## MY1 Monitoring Report

Owen Farms Mitigation Site  
Transylvania County, NC

NCDMS Project No. 100064  
NCDMS Contract No. 7532  
NCDMS RFP No. 16-007334  
(Issued 9/8/2017)

Re: MY1 Monitoring Report Comments  
Owen Farms Stream and Wetland Mitigation Site  
French Broad River Basin; CU# 06010105 – Transylvania County  
DMS Project ID No. 100064  
Contract No. 7532  
SAW-2018-01165

Figures 8.1 - 8.5 Wetland Groundwater Gauge Data

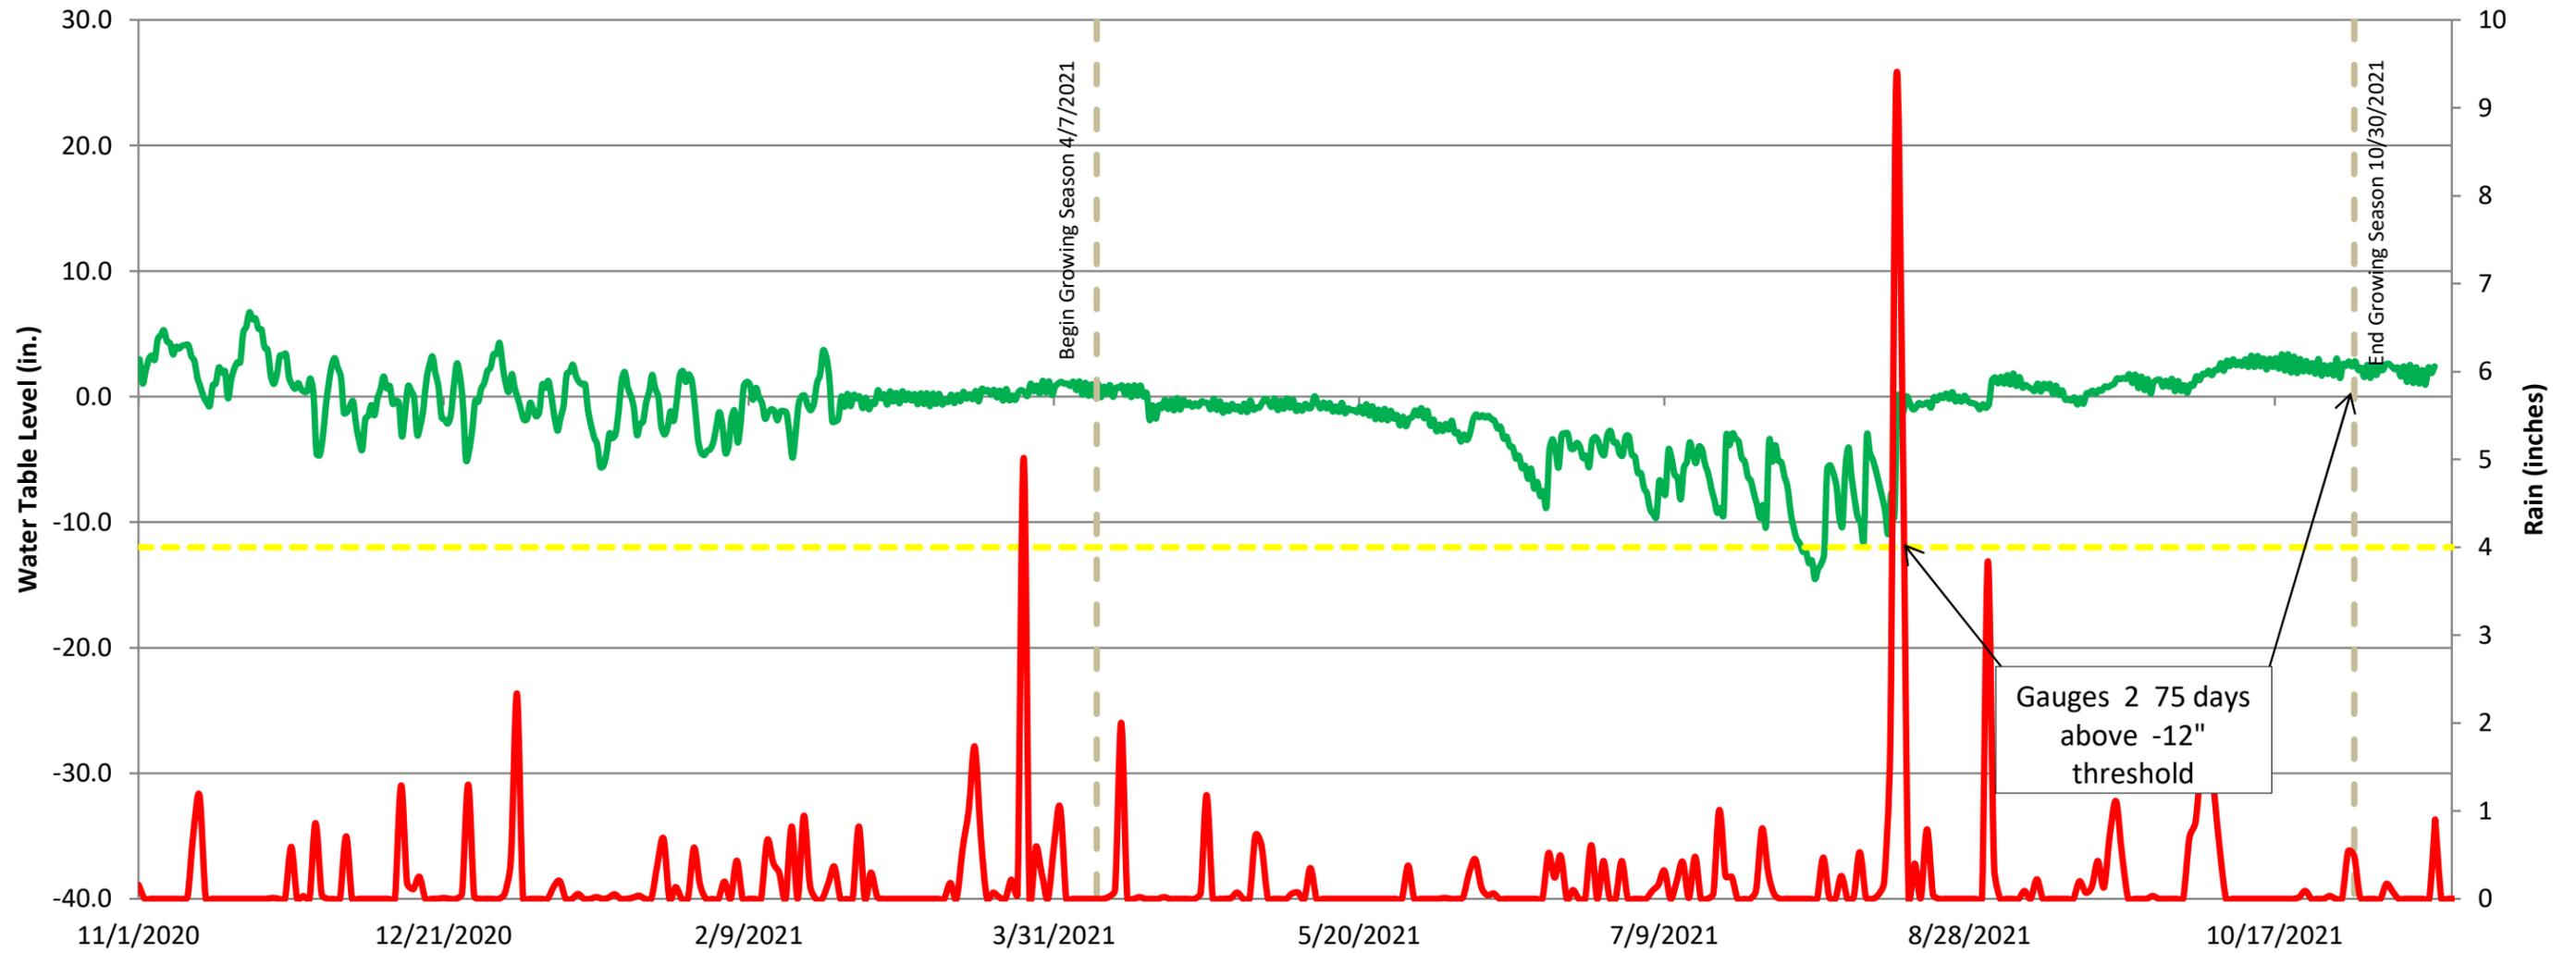
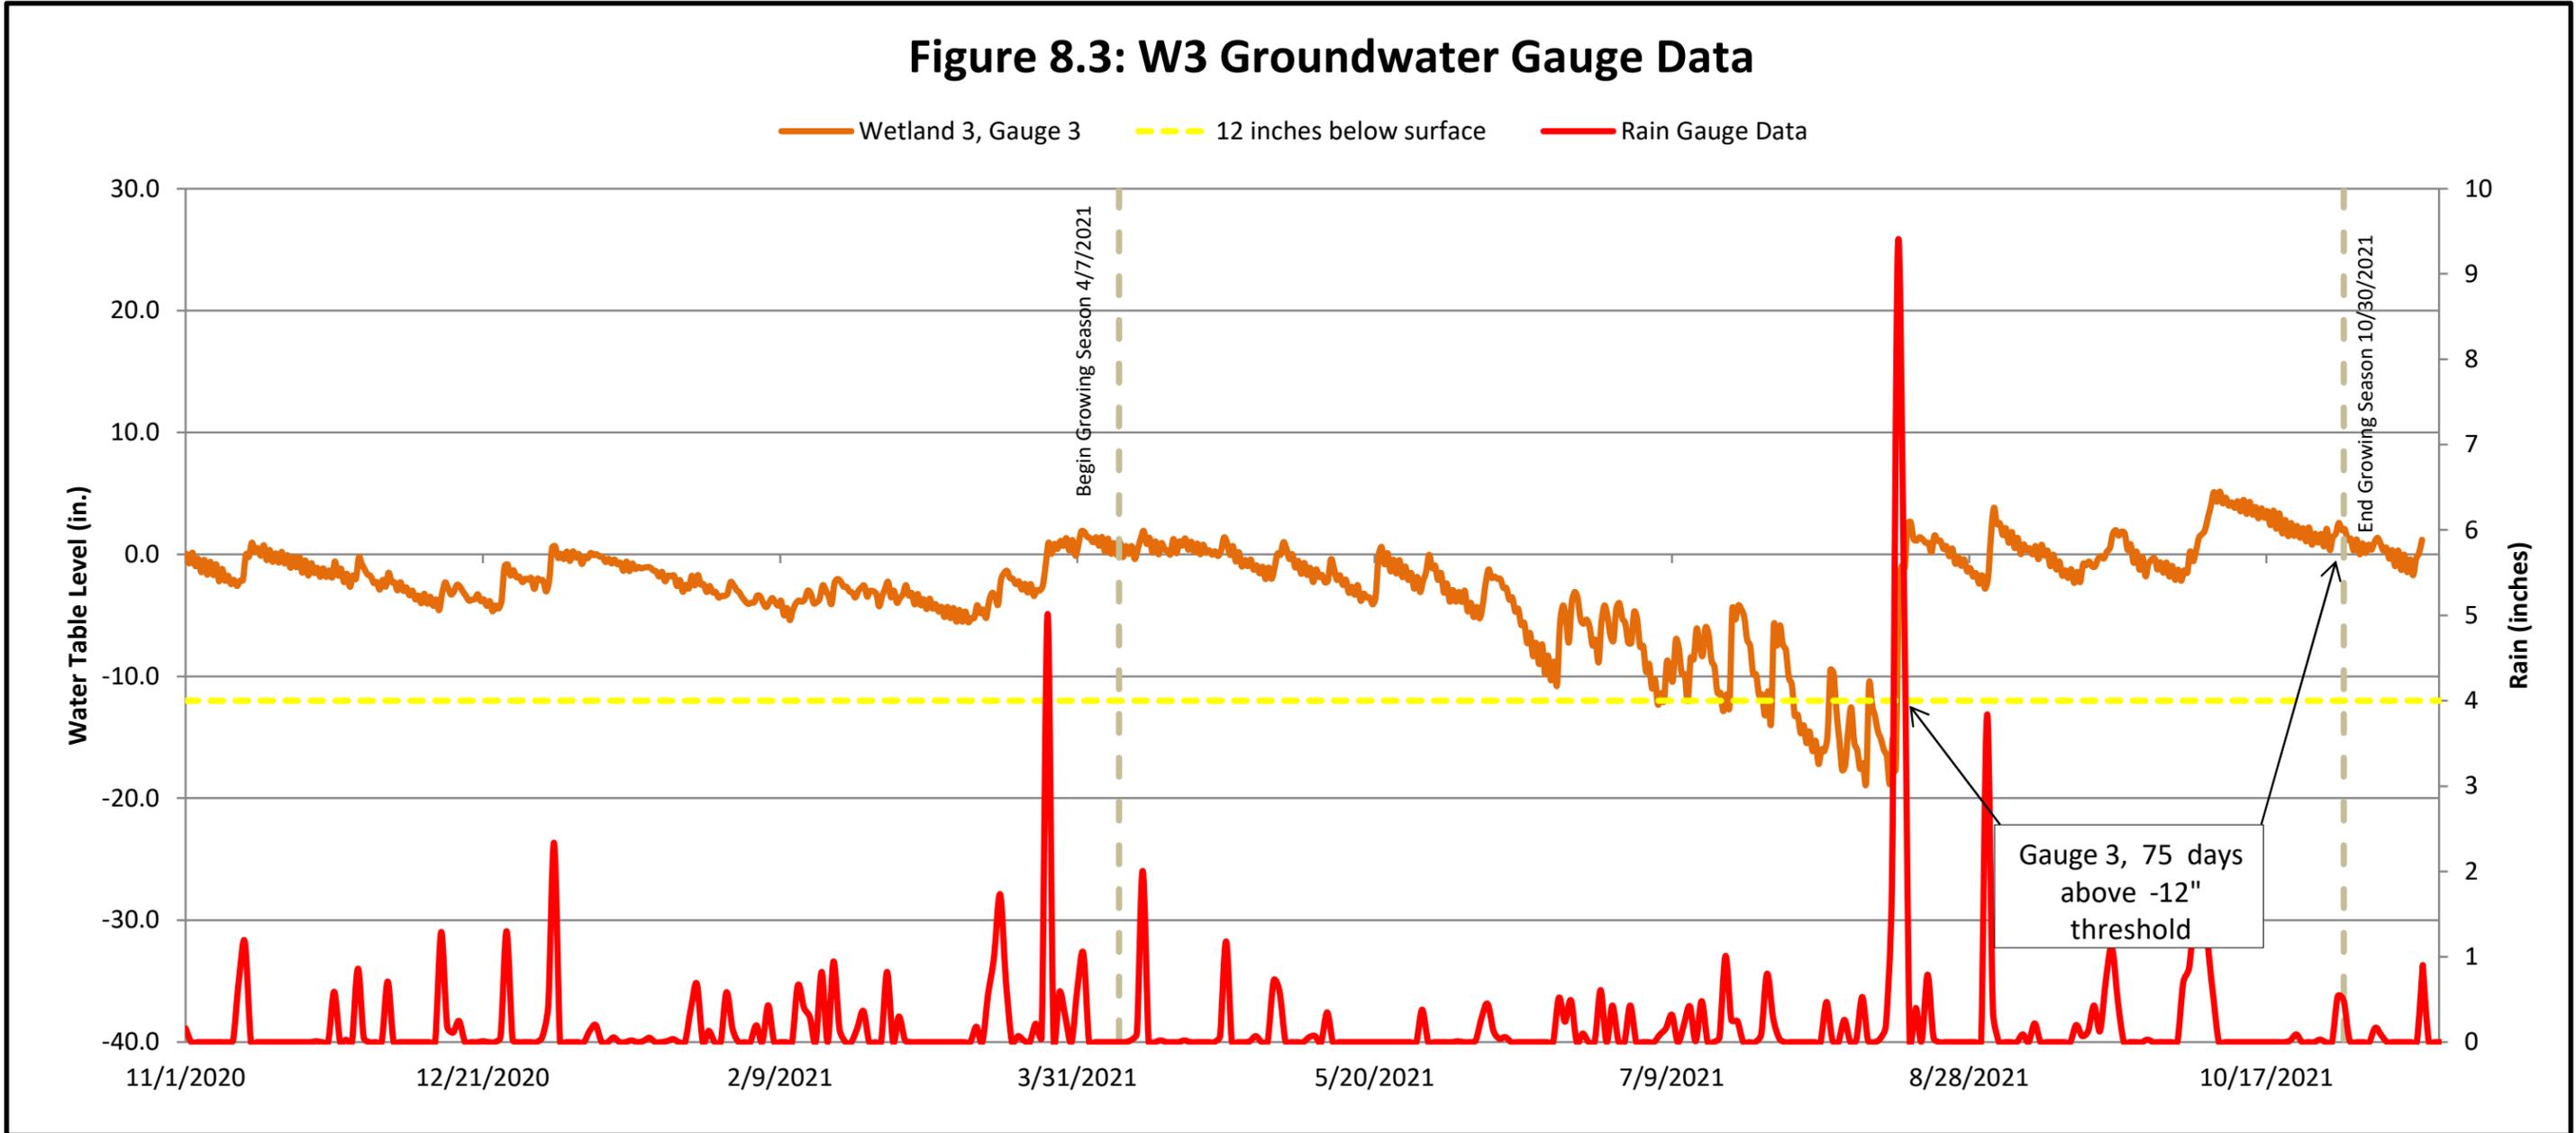
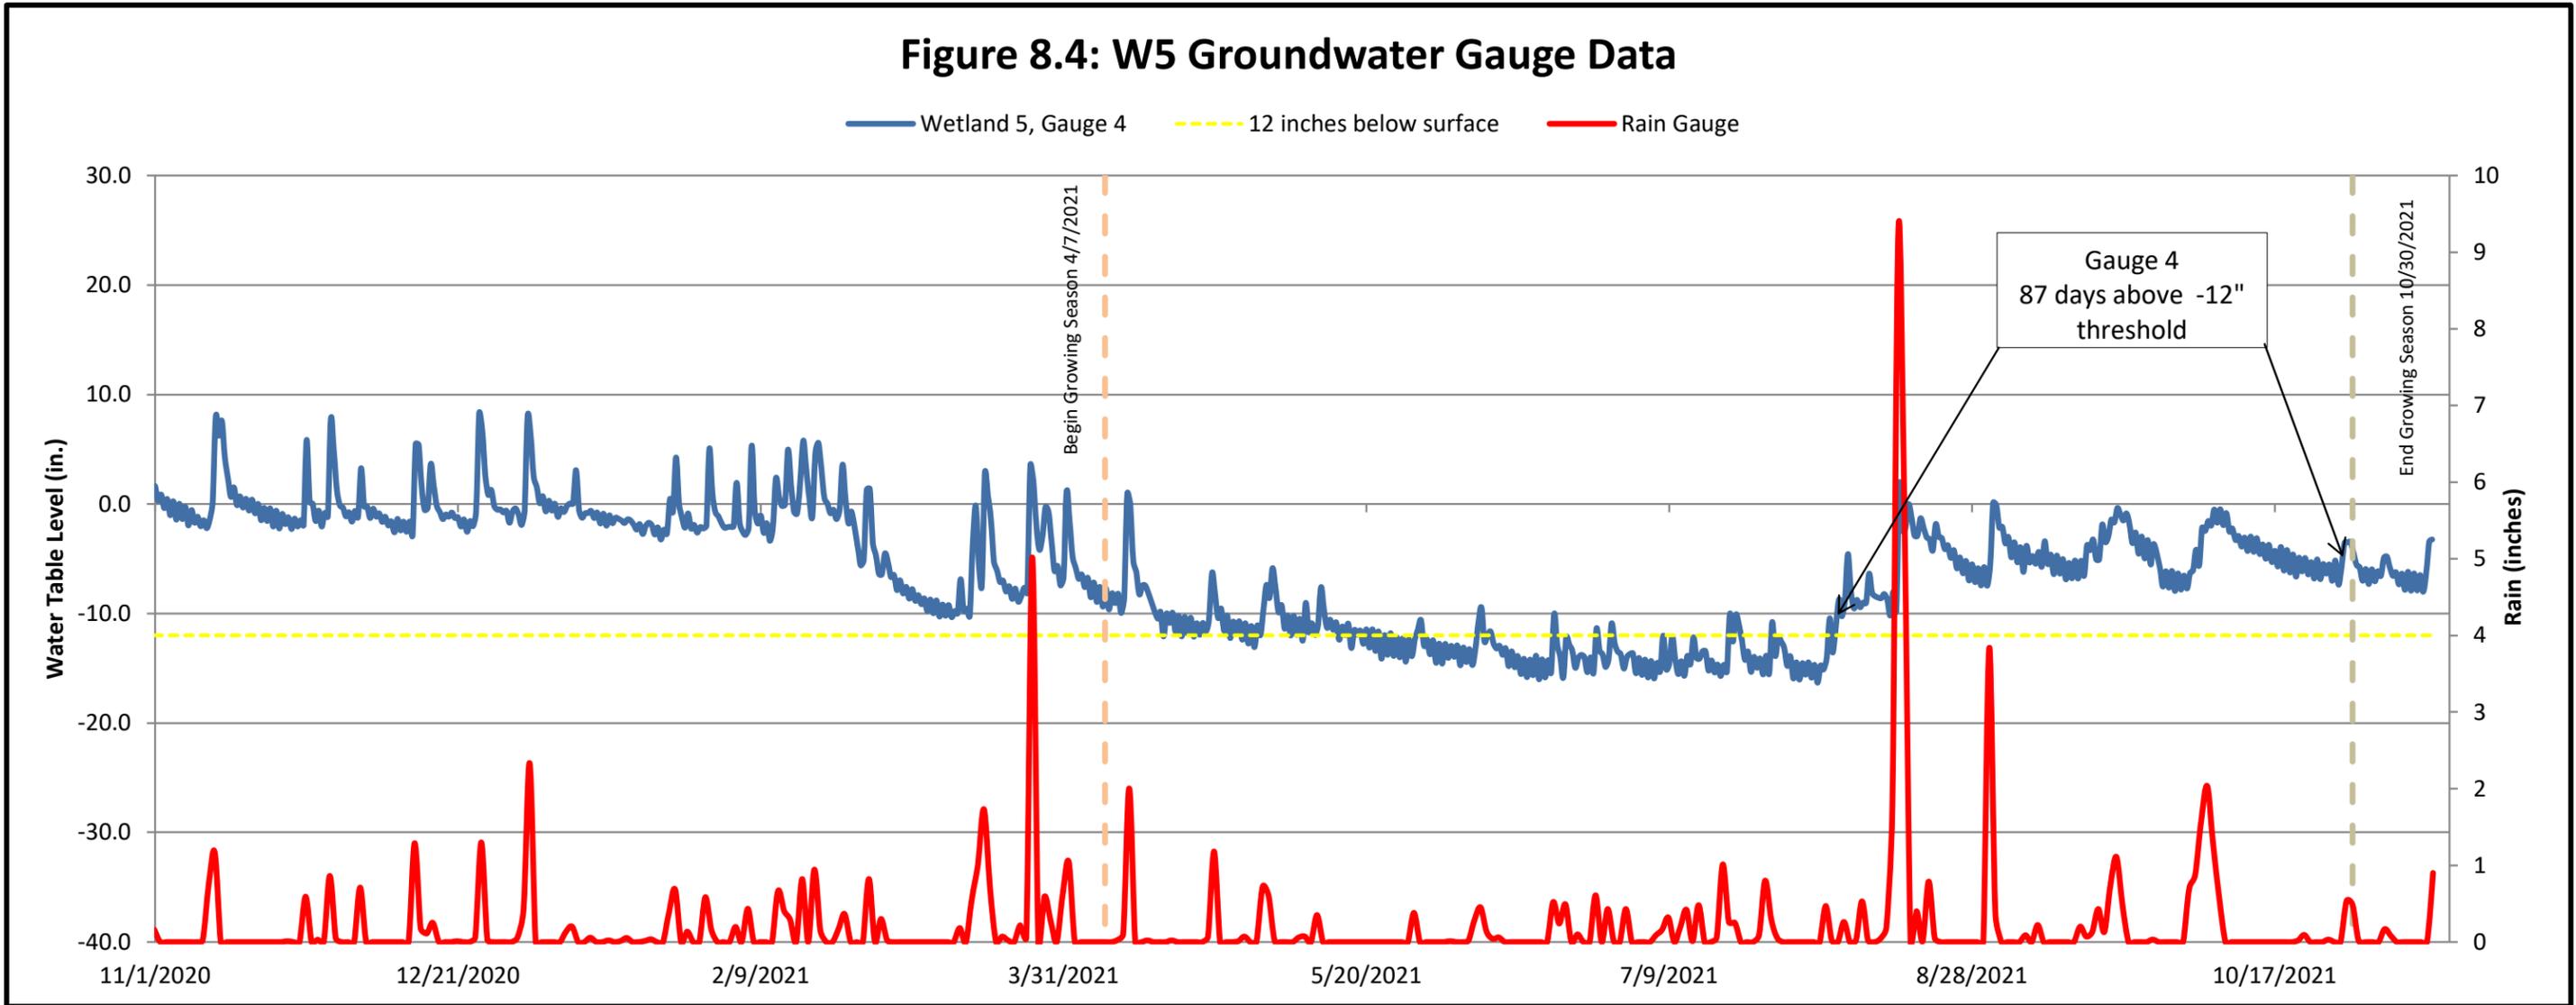
12. Please provide separate figures for each individual groundwater gauge. Please identify the maximum consecutive day number for each gauge on the individual plots/ figures. Please also review the max. consecutive hydroperiods (%) reported in Table 13. Groundwater gauges 1-3 are all reporting 75 days above the 12" threshold and the growing season is reported as 206 days ( $75/206 = 36\%$ ). Table 13 is reporting 42% for groundwater gauges 1-3. In Table 13, please include MY1/ 2021; MY2/2022; etc. Please review, QA/QC, and update the figures, table and report text as necessary *RE: Separate figures have been added to the MY 1 Report. Table 13 has been updated.*
